Mangilao Solar Project

Subject: Compliance Assessment – Order Item 1; July 29, 2021 Notice of Violation / Compliance Order / Penalty Order

SUBJECT: Site Inspections at Samsung Mangilao Solar Project Site, August 4, 2021,
for the purpose of compliance determination; Order Item 1

Interim measures plan submitted by Samsung on August 4, 2021, for Pond 4 area

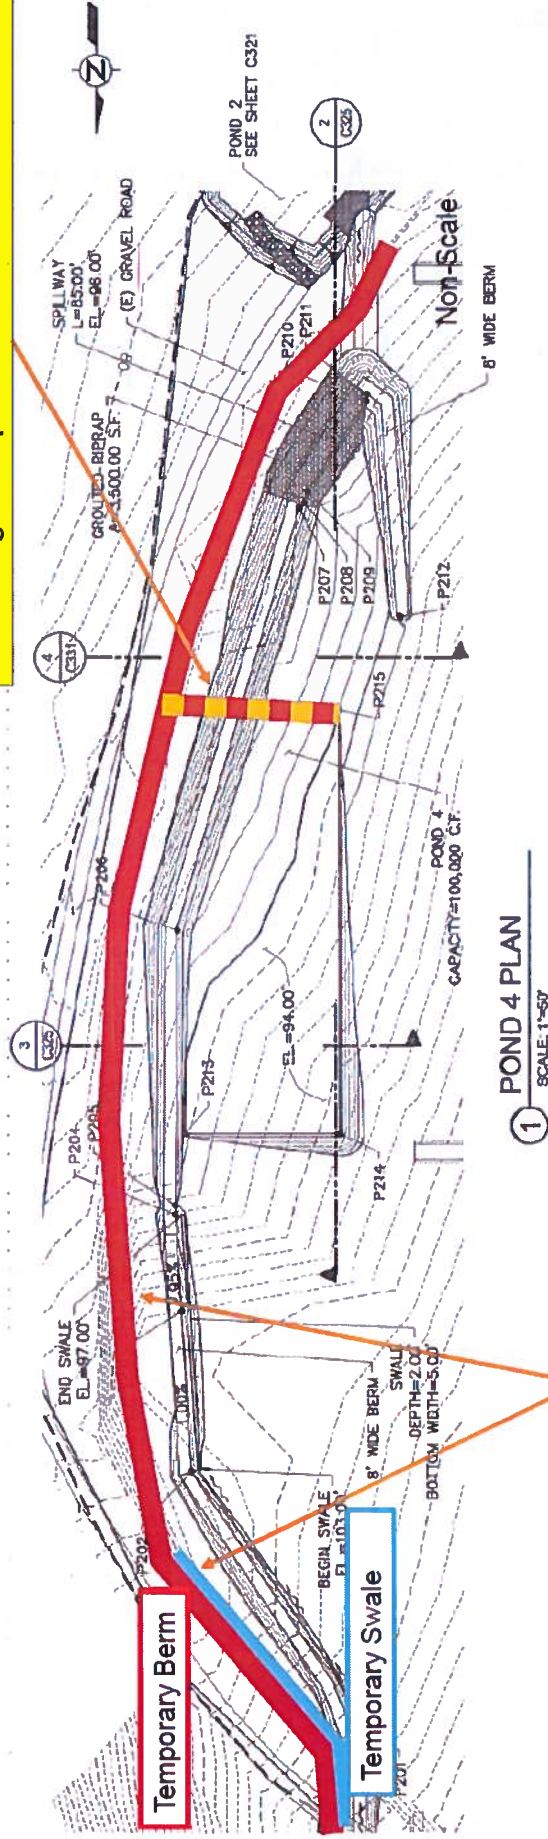
- This temporary berm position will be shifted according to the permanent berm installation.

- Construction temporary berm and swale
- This temporary berm and swale will be maintained until the end of the permanent berm and swale installation.

* Note:
- The material used to construct,
- On-site crushed and screened rock and sandy material,
- Pond 4 is compacted with roller a few times
- The elevation of the temporary berm is similar to the permanent berm.
- There has been ongoing excavation to clean sediment from the basin areas.

Interim measures plan submitted by Samsung on August 4, 2021, for Pond 5 area

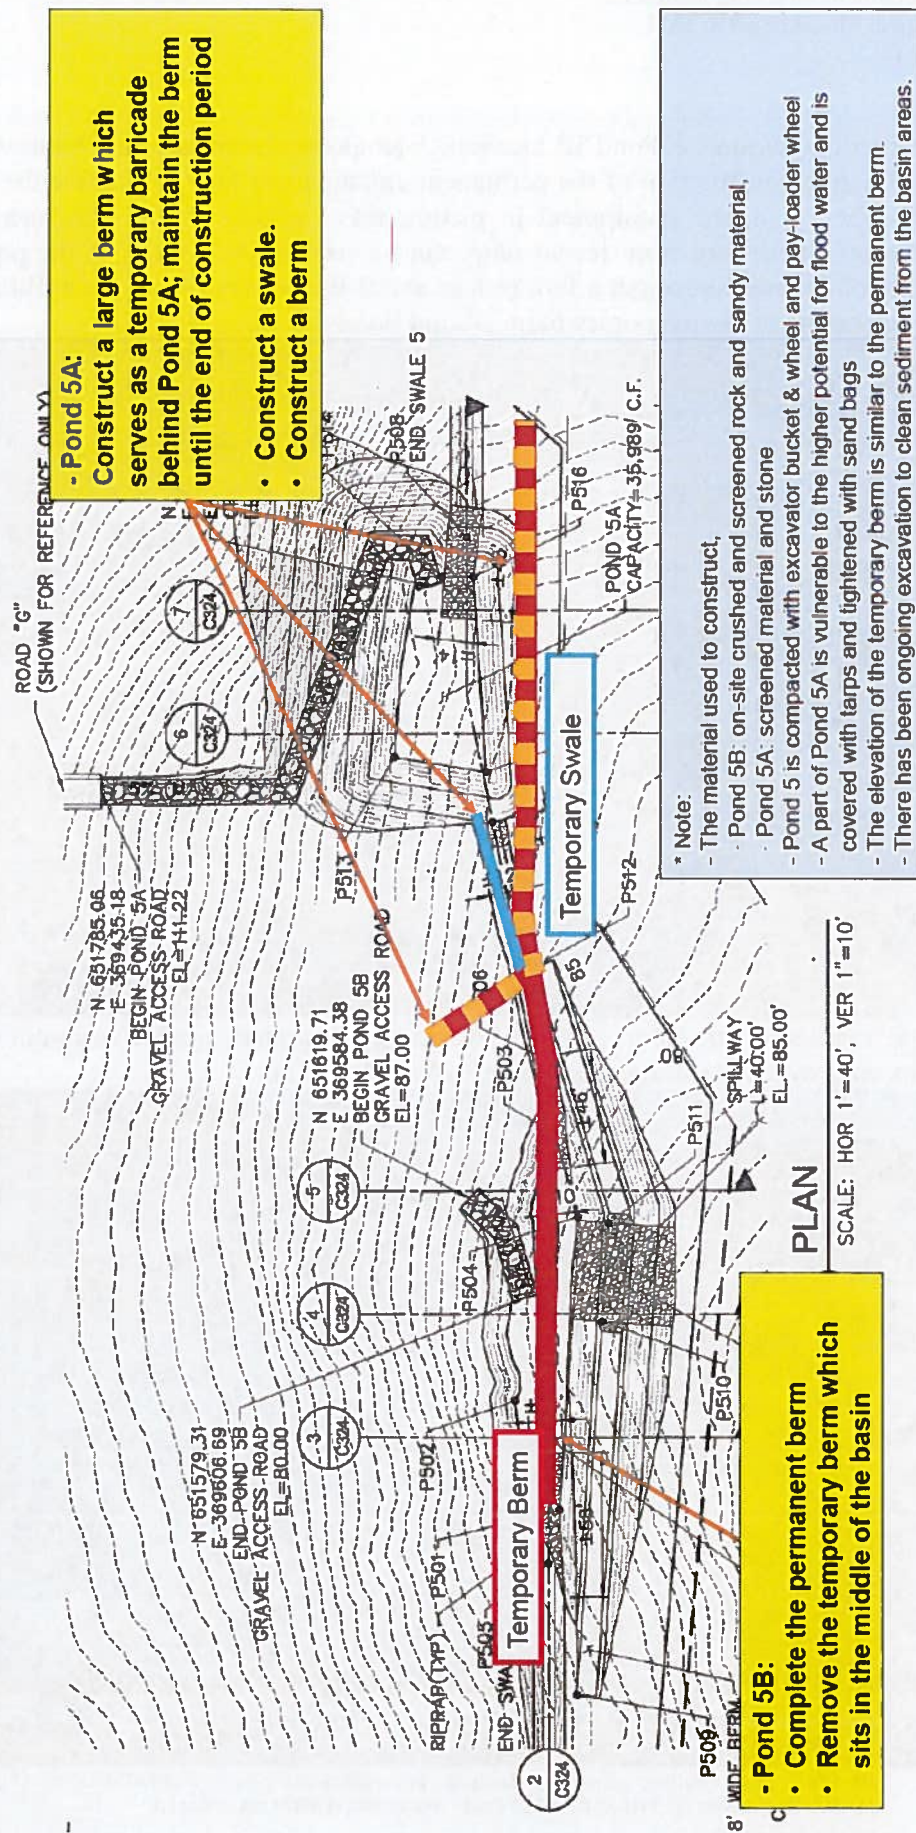
View of interim measures at Pond 5B location. A temporary berm currently holds water back from the site of active construction of the permanent embankment that will define the full volume of Pond 5B when complete (equipment in picture was working on the permanent embankment emplacement). Sediment from recent rains can be seen in the bottom of the pond, along with indications of a water line about a foot or less above the bottom of the pond. Blue plastic tarp is covering a portion of the temporary berm around Pond 5A. (Aug. 4, 2021)

Closer view of temporary berm in Pond 5A and tarp to protect against wash-out caused by flow around its end, which discharges to Pond 5B (Aug. 4, 2021)

Work underway at Pond 5B to widen incoming swale and complete surrounding grading. The temporary berm can be seen behind the excavator with the worker standing on top. The blue tarp reinforcement was placed on the same berm but to the right, outside the picture. (Aug. 4, 2021)

Overview of the area below Pond 5, outside the temporary berm and located just up-gradient from Marbo Cave. This area is protected by a single line of silt fence. The remaining soil stockpile inside this area cannot be removed due to archeological work that needs to occur (Aug. 4, 2021)

View of area outside temporary berm near Pond 5, showing flagging (orange) marking locations for archeological investigation, and stockpile of soil that still needs to be removed. (Aug. 4, 2021)

Section of silt fence showing inadequate burial of fabric, and erosion of soil that occurred on recent rain event. Silt fence fabric remained in place, however, likely due to the use of wire mesh backing as reinforcement. Samsung stated that they would correct this immediately. (Aug. 4, 2021)

View looking past the silt fence just outside of Pod 5 area, down the trail toward Marbo Cave. Erosion from rainfall events of the previous day can be seen in the form of soil scoured from the improperly buried bottom section of the fence fabric. It appears that the silt fence was effective at preventing discharge toward Marbo Cave at this location. (Aug. 4, 2021)

View from silt fence-protected area outside the temporary berm around the Pond 5 area, looking back toward active construction (compaction) of Pond 5B. The temporary/interim berm can be seen partly covered by the blue tarp on the right, and behind the compaction equipment on the left. (Aug. 4, 2021)

1. Continuous inspection and maintenance of erosion and sediment control (E&SC) best management practices (BMPs) is required. In particular, these measures must be inspected after every rainfall event, and serviced as necessary.
2. All silt fence must be installed with the bottom portion of the fabric buried in accordance with standard installation instructions. The use of sandbags or other materials to hold the fabric down on top of the original grade is not adequate. This is especially important in areas which receive substantial runoff or are located near other properties, such as (but not limited to) the area directly upgradient of Marbo cave, and the area below the Pond 3 area. Please refer to the 2006 CNMI & Guam Stormwater Management Manuals (adopted under Executive order 2012-02) available on our website here:
<http://epa.guam.gov/programs/water-pollution-control/>

3. The area between the Pond 5 system and the site boundary must be stabilized as soon as possible through revegetation or other means to prevent the stockpiled soils and bare surfaces in this area from washing off-site toward Marbo Cave. GEPA acknowledges that Respondent has been told not to disturb this area until archeological work is completed. Therefore, until the archeological work is completed and Respondent can begin soil stabilization work, extra attention must be paid to the maintenance of the silt fence at this location.
